South End Sweater Co Ltd.

14th February 2015

Observations

**Cantilevered Slab at 3rd
floor level**

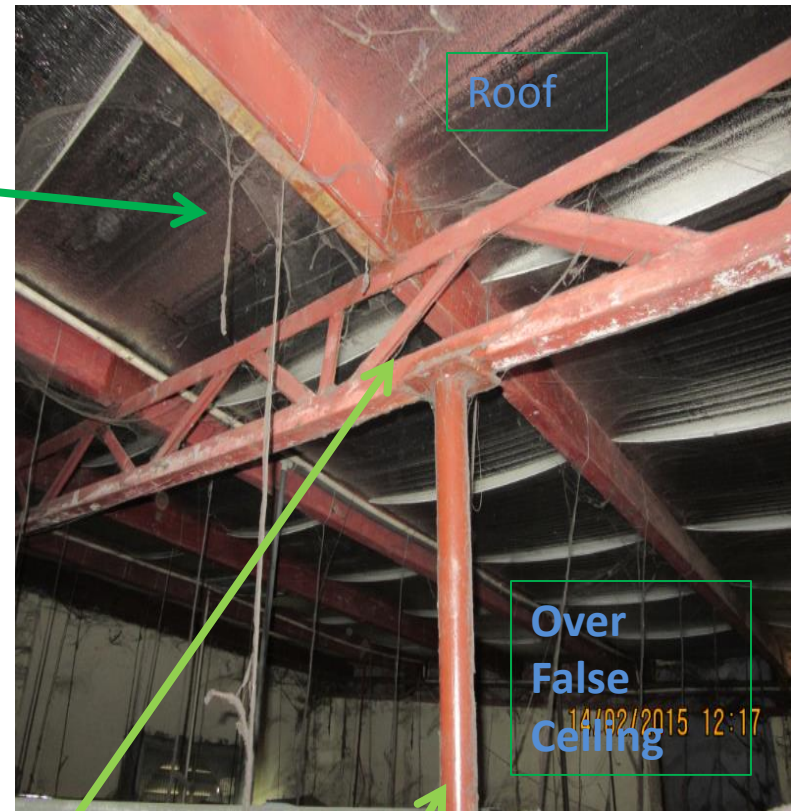
**Cantilevered walkway south of main
building at 3rd floor level not on drawings**

6	Cantilevered walkway south of main building at 3rd floor level not on drawings	Carry out remedial works as required	6-months
7	Cantilevered walkway south of main building at 3rd floor level not on drawings	Update as "built drawings"	6-months
8	Apparently non-engineered roof structure in Shed 1 Building B2	Factory engineer to check that 60mm diameter Circular Hollow Section (CHS) columns have sufficient capacity to support roof.	6-weeks
9	Apparently non-engineered roof structure in Shed 1 Building B2	Engineer to confirm roof truss bottom boom has capacity to support CHS bending and shear stresses.	6-weeks
10	Apparently non-engineered roof structure in Shed 1 Building B2	Carry out remedial actions as required	6-months
11	Permit Approval for two Extension to South of Main Building still required	Owner liaise with local authority to establish status of Building Permit for Two Story Extension to South of Main Building	6-months

East Elevation Building B 2

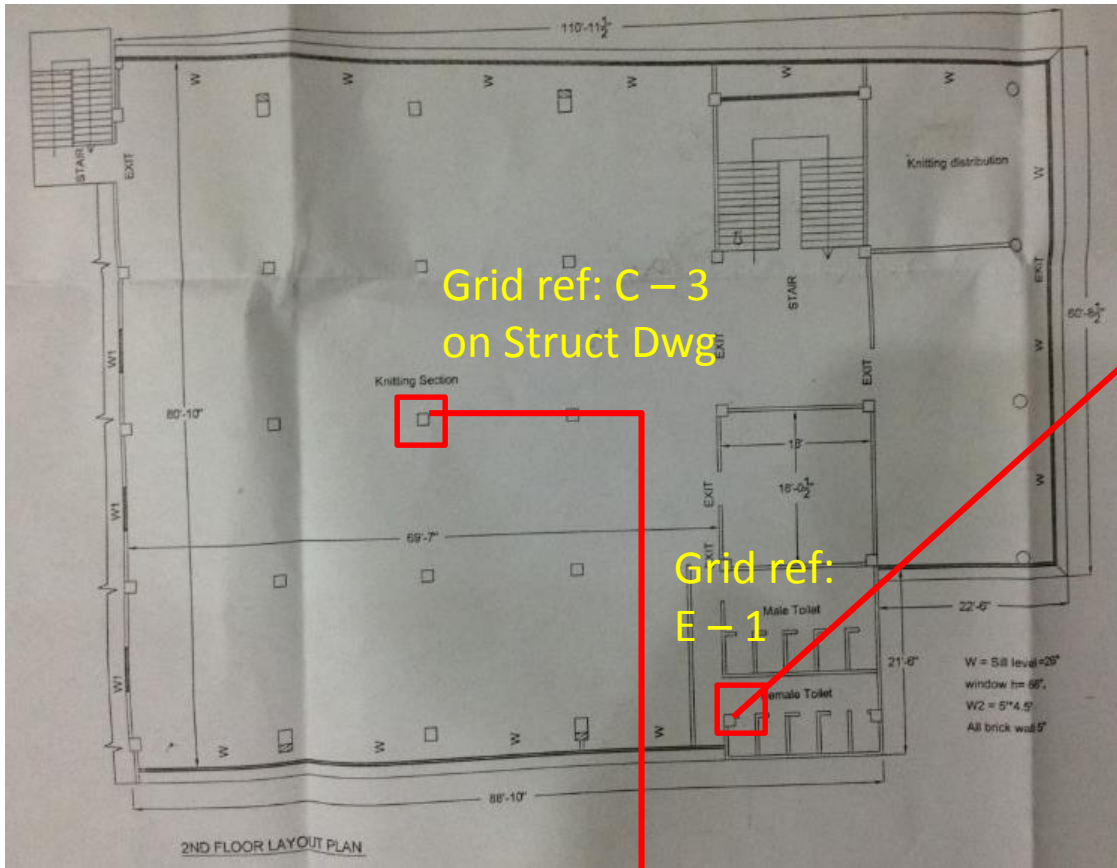
Apparently non-engineered roof structure in Shed 1 Building B 2

60mm Circular Hollow Section
support.
Support not under nodal
point on truss.

Column Testing

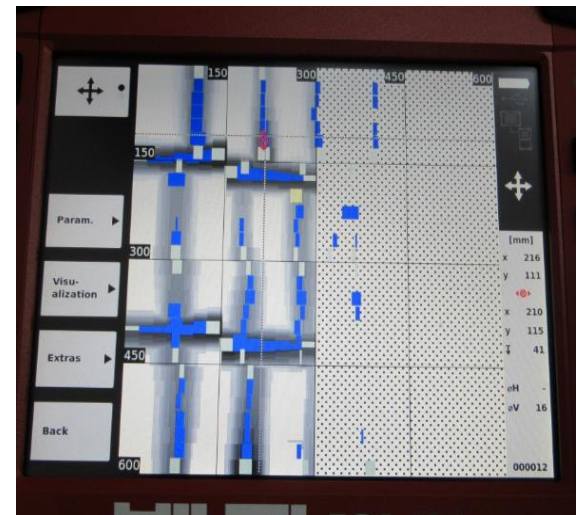
Reinforcement scan agrees with drawing information and reinforcement at the tested column
